# Access Compliance Report

## Public Rights-of-Way

Intersection ID: 14314	Main Street: TREMONT_ST	Cross Street: SOUTH_BV	Location: NW
ADA ID: 8ED59FD356EF	Ramp Type: Perpendicular	Initial Pass/Fail: Fail	Overall Compliance: No
Codes/Mitigation Info/Possible Solution		Field Measurements/Component Compliance

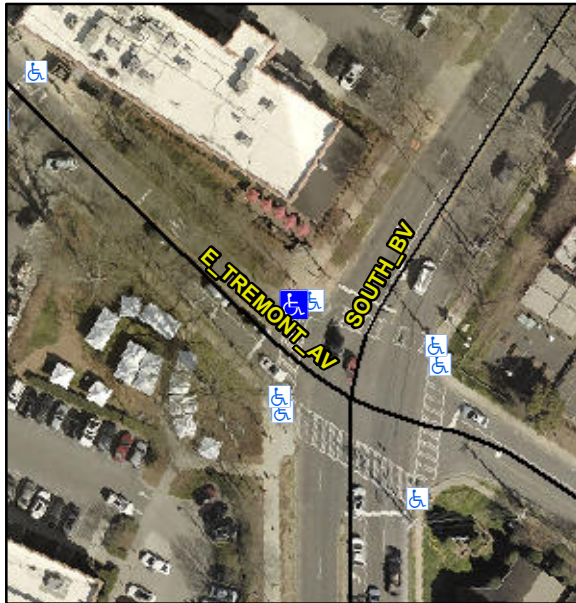
**R304.2.2**

Compliance	Description	Data	Compliance	Description	Data
N/A	Ramp Length (in)	64.0	No	Ramp Slope (%)	9.0
Yes	Ramp Width (in)	48.0	Yes	Ramp XSlope (%)	2.3
N/A	Flare Type LT	N/A	N/A	Flare Type RT	N/A
N/A	Flare Slope LT (%)	N/A	N/A	Flare Slope RT (%)	N/A
N/A	Flare Traversable LT?	N/A	N/A	Flare Traversable RT?	N/A
N/A	Landing Length (in)	N/A	N/A	DWS Provided?	N/A
N/A	Landing Width (in)	N/A	N/A	DWS Contrast?	N/A
N/A	Landing Slope (%)	N/A	N/A	DWS Length (in)	N/A
N/A	Landing X Slope (%)	N/A	N/A	DWS Full Width?	N/A
N/A	Landing Curb? (Y/N)	N/A	N/A	DWS Offset (in)	N/A
N/A	Shared Landing?	N/A			
N/A	Gutter Ponding?	N/A	N/A	Gutter Slope (%)	N/A
N/A	Gutter Lip Ht (in)	N/A	N/A	Gutter X Slope (%)	N/A
N/A	Painted X Walk1?	Yes	N/A	Painted X Walk2?	N/A
	X Walk 1 Direction	To SW		X Walk 2 Direction	N/A
N/A	X Walk 1 Width (in)	121.0	N/A	X Walk 2 Width (in)	N/A
	X Walk 1 Slope (%)	10.3		X Walk 2 Slope (%)	N/A
	X Walk 1 X Slope (%)	2.9		X Walk 2 X Slope (%)	N/A

**Remove & Replace Entire Ramp.**
